# Union of Concerned Scientists

November 4, 2011

## SUBJECT: Conditional Allegation – Shield Building Design at Davis-Besse

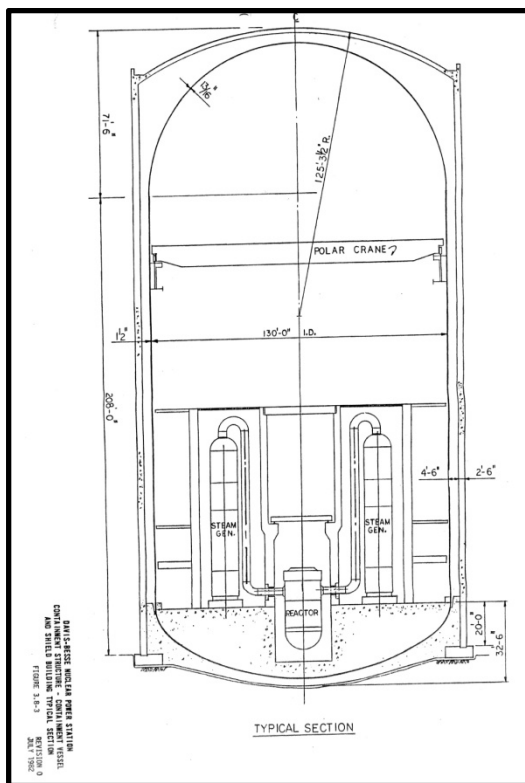
1. The “non-structural, architectural concrete” elements do not appear in UFSAR Figure 3.8-3. The plan diagram indicates these elements are connected to the shield building wall. Are the dead loads from these concrete elements properly considered in the design analyses of the shield building?
2. The UFSAR does not explicitly describe these “non-structural, architectural concrete” elements. Thus, it is not clear if these elements have Type II concrete or Type I cement as explained in UFSAR section 3.8.2.3.7. What type of cement was used in the “non-structural, architectural concrete?”
3. If the concrete/cement in the shield building is the same as that in the “non-structural, architectural concrete” elements and all have the same age and environmental exposure history, would numerous cracks identified in one suggest comparable conditions in the other? If not, why not?

UCS realizes that UFSAR Figure 3.8-3 is a simplified drawing and the design analysts hopefully used the more detailed civil/structural arrangement drawings, but it is prudent to check to verify

This plan diagram (overhead view) of a section of the shield building wall shows the “non-structural, architectural concrete” referred to in the NRC’s PNO. As indicated by the two fish-hook shaped devices in the drawing, the attachments are anchored to the shield building wall.

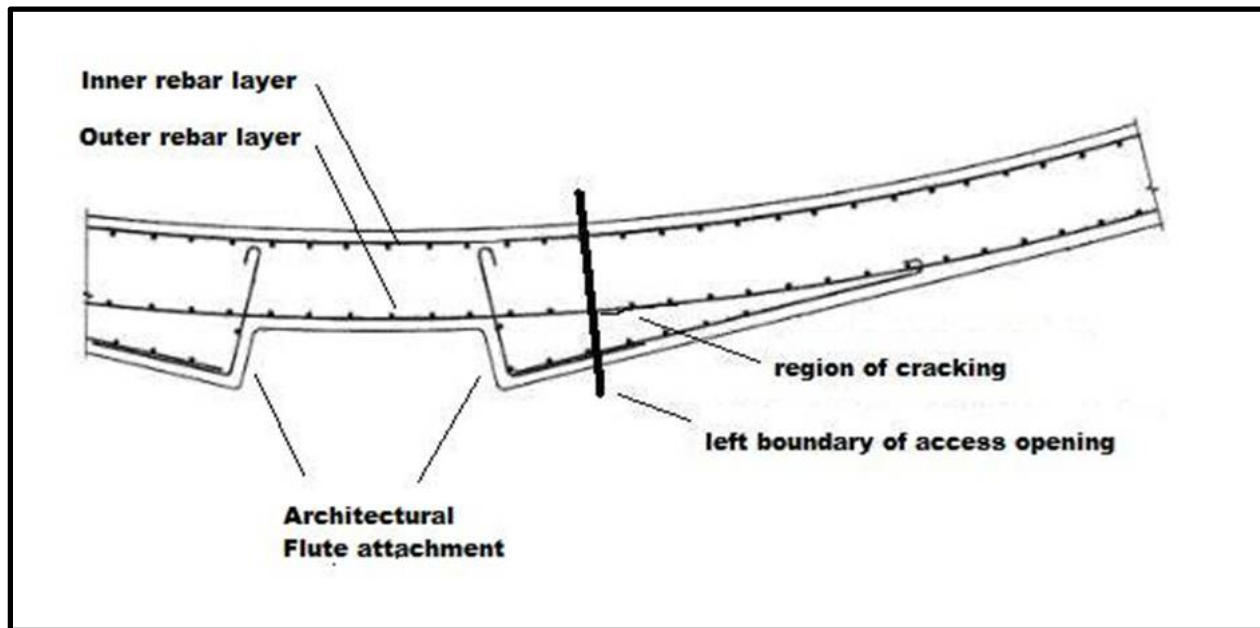
1. The design evaluation and analysis for the shield building did not properly consider the dead load from the "non-structural, architectural concrete" attached to it.
2. The shield building wall was not sufficiently examined for indication of cracking.
